## SERVICE BULLETIN

**APPLICABILITY:** 2012-19MY Forester  
 2012-19MY Impreza  
 2015-19MY WRX

**NUMBER:** 02-131-12R  
**DATE:** 07/18/12  
**REVISED:** 01/22/21

**SUBJECT:** Oil Seepage Diagnosis and Repair Procedures

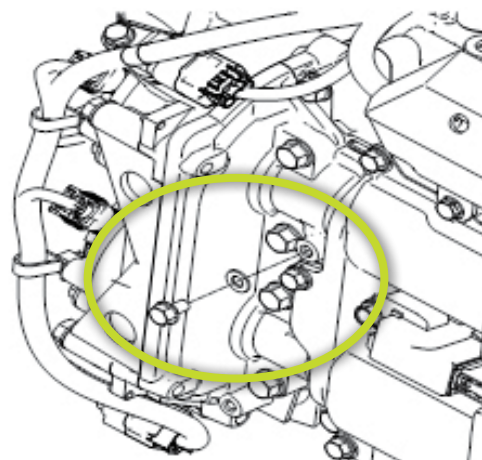
There are five areas that should be closely inspected if an oil leak is reported by the customer:

1. The 6mm tapped hole casting boss area in the left-hand camshaft cap
2. The sealing surfaces between either the left or right-hand camshaft cap and camshaft carrier
3. The sealing surfaces between the cylinder head and camshaft carrier
4. The sealing surface between the upper oil pan and the engine block
5. The sealing surfaces of the front timing chain cover

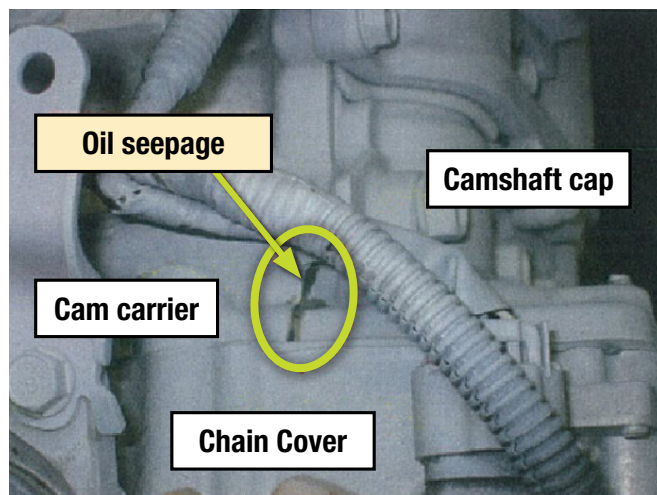
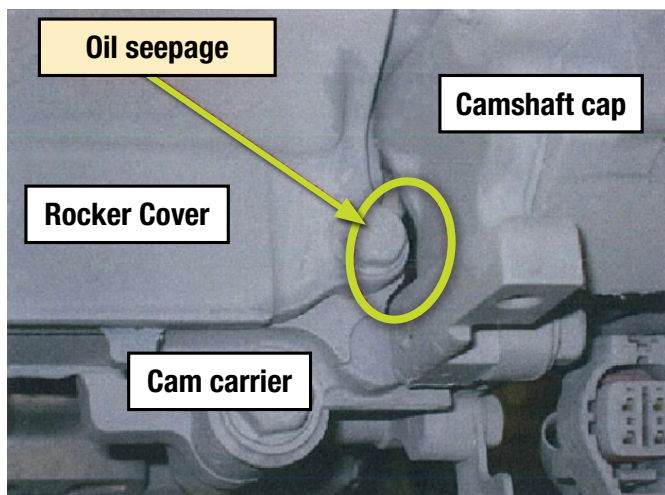
If oil seepage is verified coming from the 6mm threaded hole in the left-hand camshaft cap, install the specified bolt and flat washer.

**Bolt:** Part# 800206180

**Washer:** Part# 031106000

**Tightening Torque:** 6.4 +/- 0.5 Nm  
 (57 +/- 4 inch-pounds)

**Right Hand**

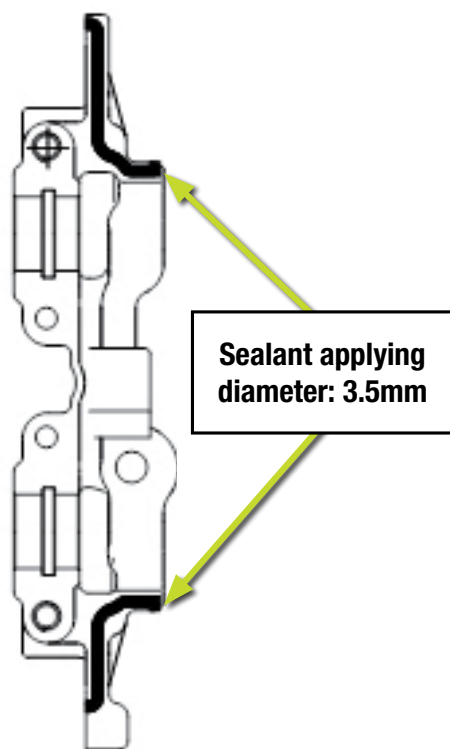
If oil seepage is verified coming from the front camshaft cap or cam carrier as shown in the photos below, remove the cam cap and clean both surfaces thoroughly before applying sealer. **Note:** The 2 o-rings between the camshaft cap and the cam carrier will need to be replaced as they are not re-usable.

Apply Liquid Gasket, ThreeBond **11217H (SOA868V9610)** or equivalent\* as shown below:

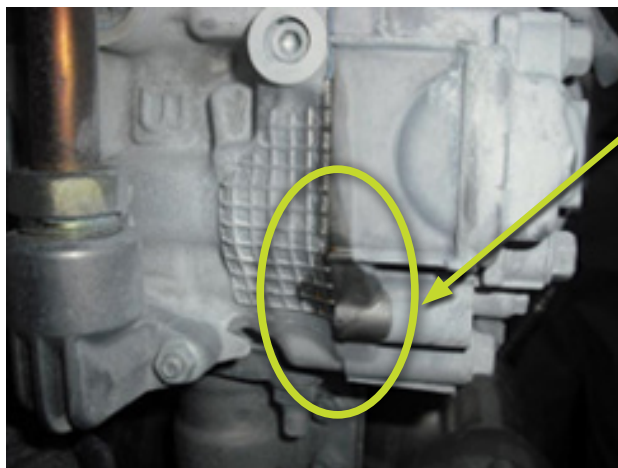
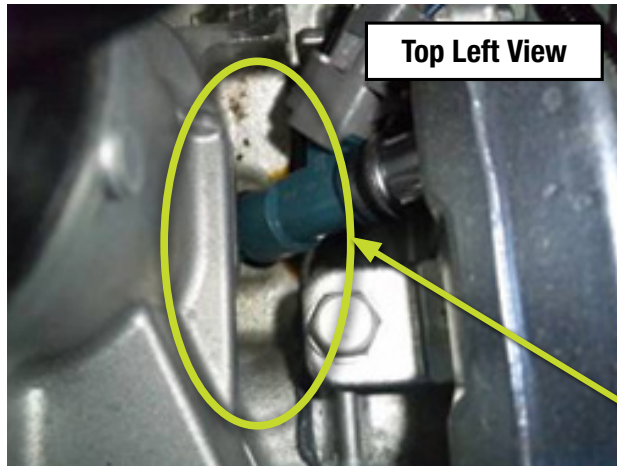
If oil seepage is verified coming from between the cam carrier and the cylinder head as shown in the photos below, remove the cam carrier. Clean the machined sealing surfaces thoroughly and then re-seal using Liquid Gasket ThreeBond 1217H (SOA868V9610) or equivalent\*. As shown in the photos below, the o-rings between the cam carrier and the cylinder head will need to be replaced as they are not re-usable. This would also be a good time to clean the Active Valve Control System (AVCS) filter screens which are contained in the cam carriers. **NOTE:** The filter screens are one-time use and must be replaced if they need to be removed. The replacement filter part# is 14451AA050.

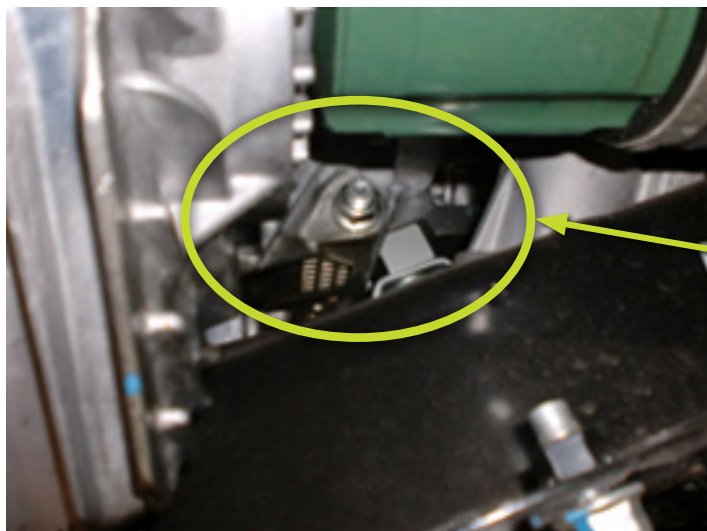
If you find engine oil seepage between the cylinder block and upper oil pan, remove the upper oil pan, clean the machined sealing surfaces thoroughly and then re-seal using Liquid Gasket ThreeBond **1217H (SOA868V9610)** or equivalent\*. **Note:** The o-rings between the upper oil pan and the cylinder block along with those between the upper and lower oil pan will need to be replaced as they are not re-usable.

**As viewed from the rear, oil seepage from the upper pan to engine block sealing area may be present in these areas.**

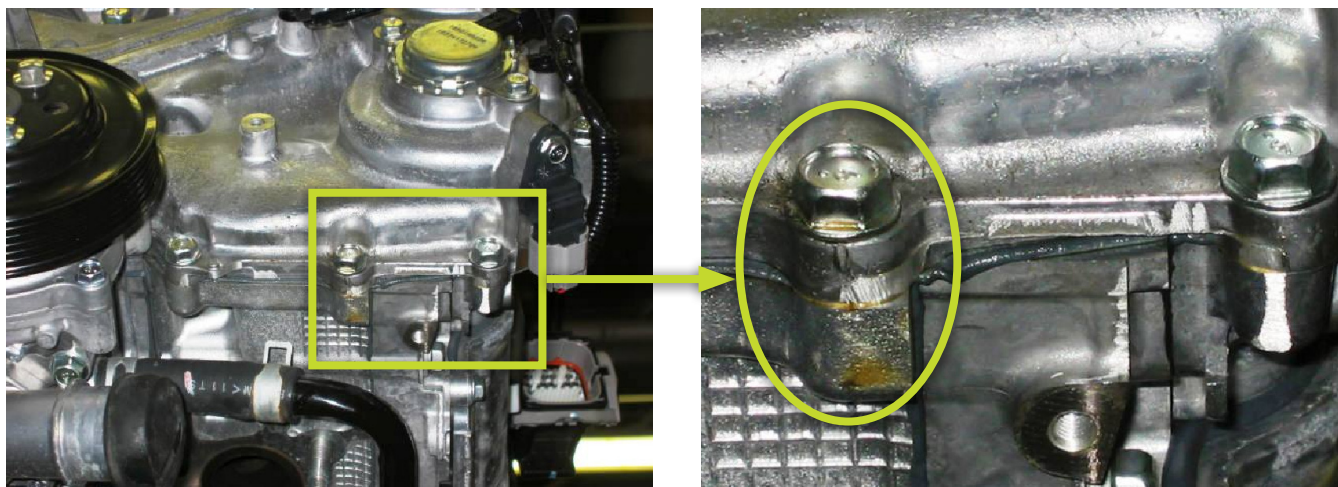
Photo shows seepage from upper oil pan to engine block sealing surfaces.
